INTERIOR ELEVATIONS

A70.04

100% CONSTRUCTION

GYM 071 - ELEVATION 1

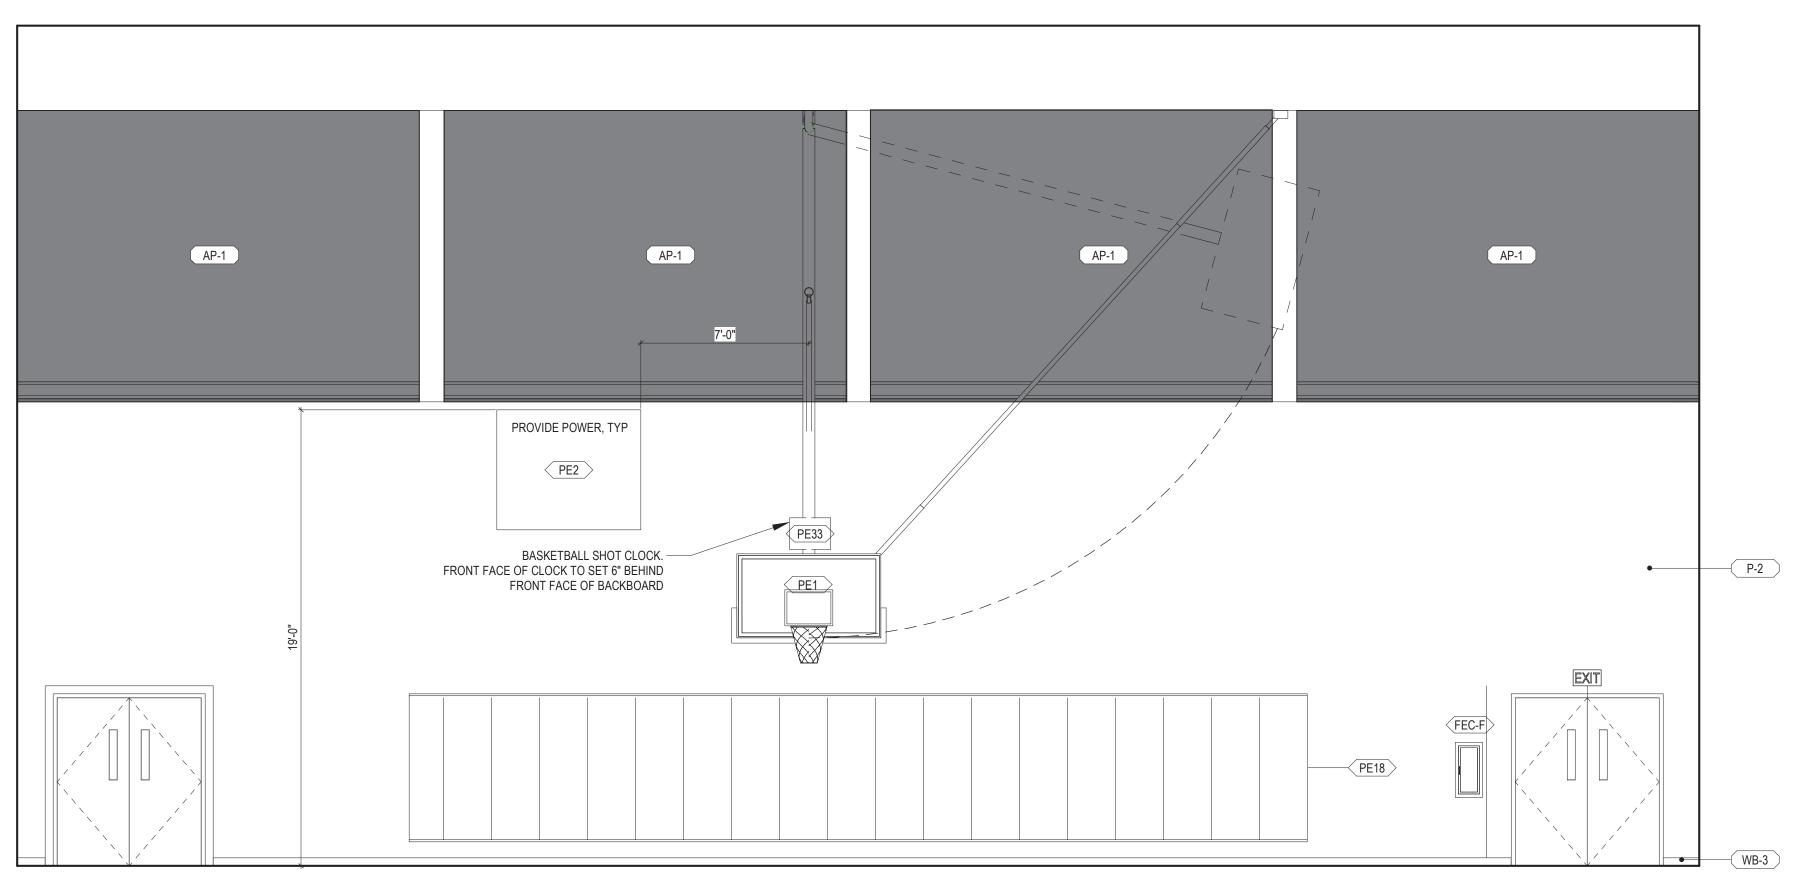
Reference QTS RFI 190 -Added aisle to bleachers per BIA comments

Also Reference QTS RFI 138 - Aisles & Row Spaces of Telescoping Bleachers
